From: Ron Wolanski, Town Planner

Date: October 1, 2024

Re: **Public Hearing** - Application of 72 Johnny Cake Hill, LLC for Development Plan Review for modification to a previously approved plan for construction of a 15,000 sq. ft. wholesale commercial use building, with associated parking, office space, landscaping, stormwater management, utilities, and associated site work, and including requests for waivers from certain design requirements of Section 521 of the Middletown Rules and Regulations Regarding the Subdivision and Development of Land. Property located on 72 Johnnycake Hill Road, Assessor's Plat 114, Lot 601.

USE 8" TOP KNOCKOUT, INV.=74.38
 BOTTOM OF CHAMBERS = 73.00
INLET MANIFOLD DETAIL
INFILTRATION SYSTEM (US1) (SC-740)
 NOT TO SCALE

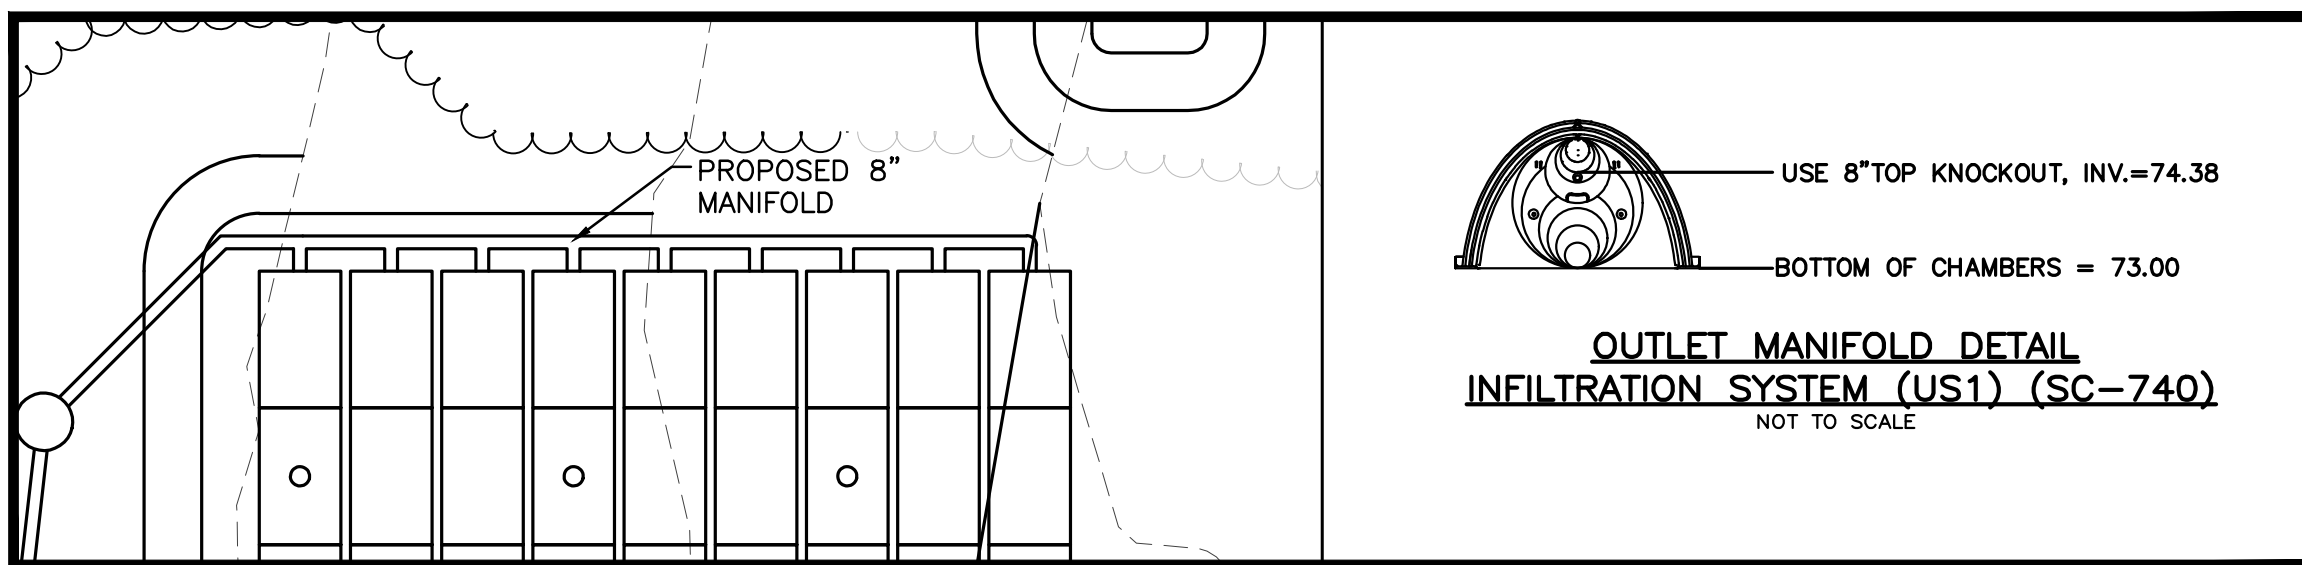
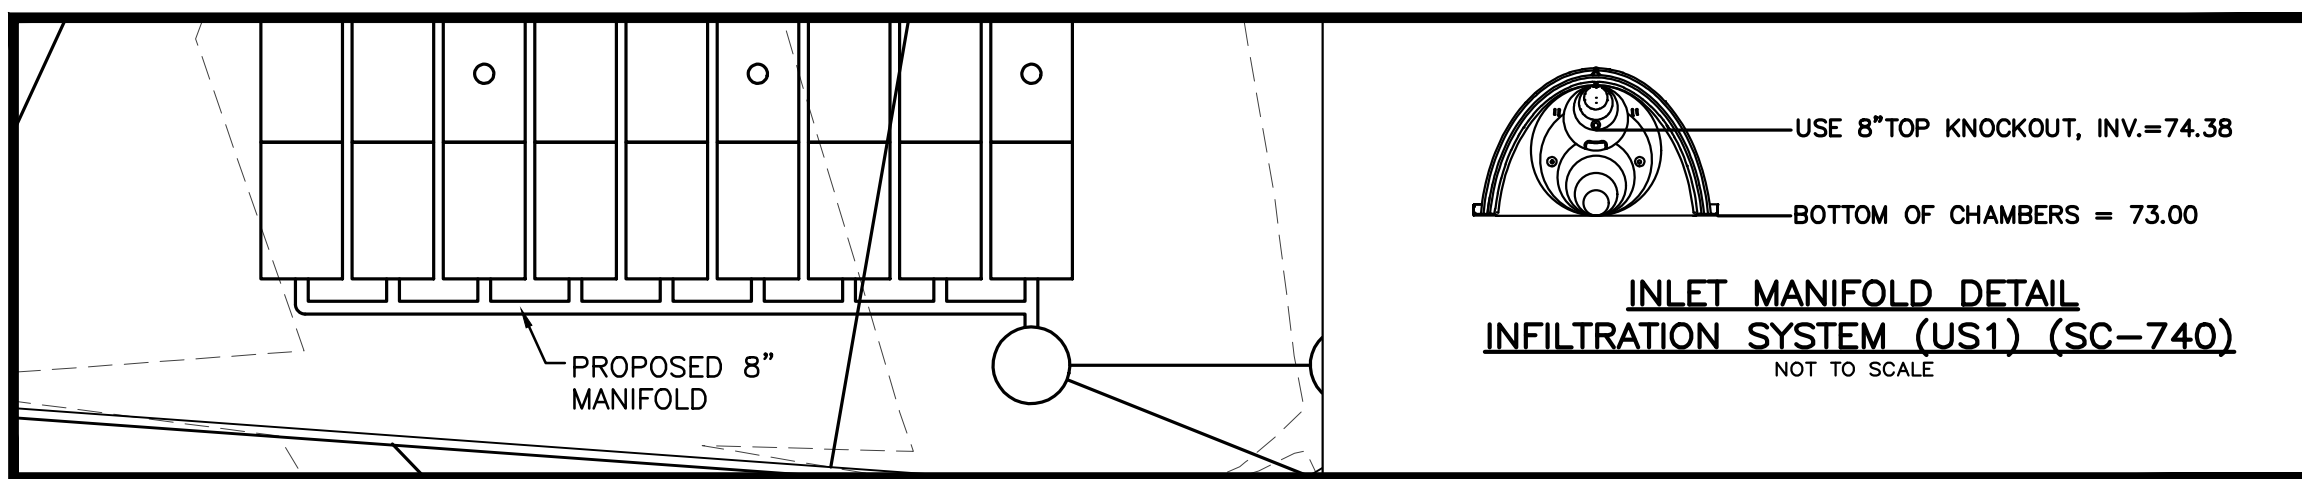
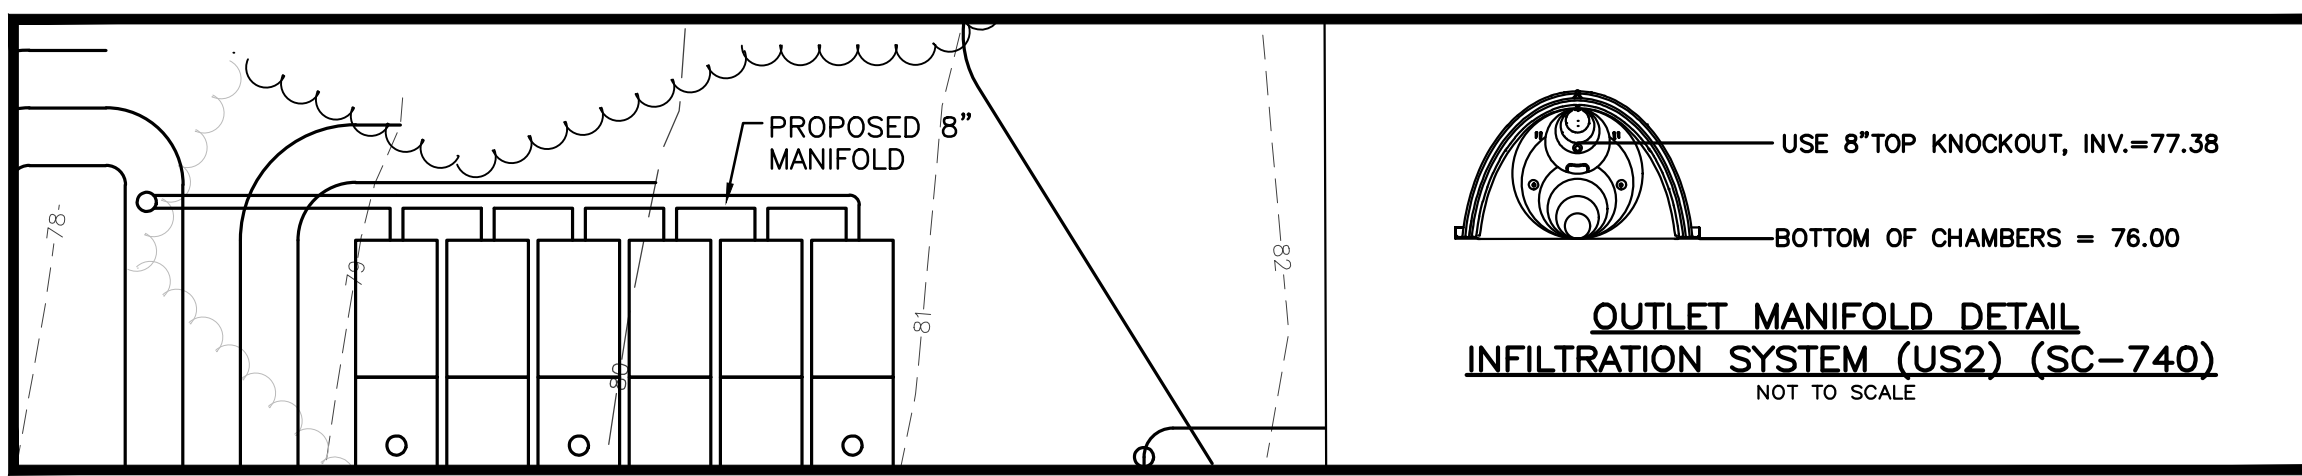
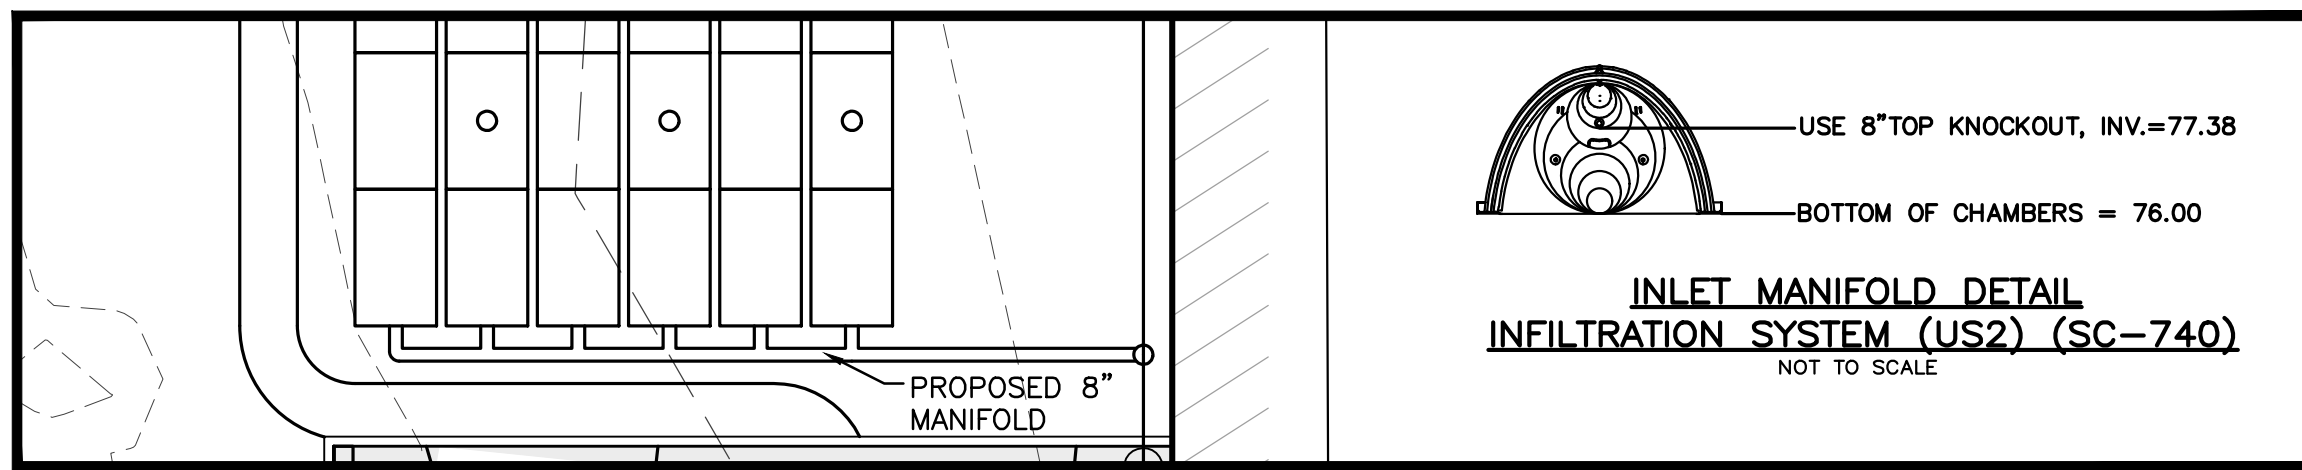
- 5. UIC 1:** The system width shown on the Plan View Detail (sheet 9) indicates 34.75-ft, as opposed to the design width of 44.25-ft in the calculations. Also, the manifold pipe sizes should be identified.

- 6. UIC 2:** The system width shown on the Plan View Detail (sheet 9) indicates 34.75-ft, as opposed to the design width of 30-ft in the calculations. Also, the manifold pipe sizes should be identified.
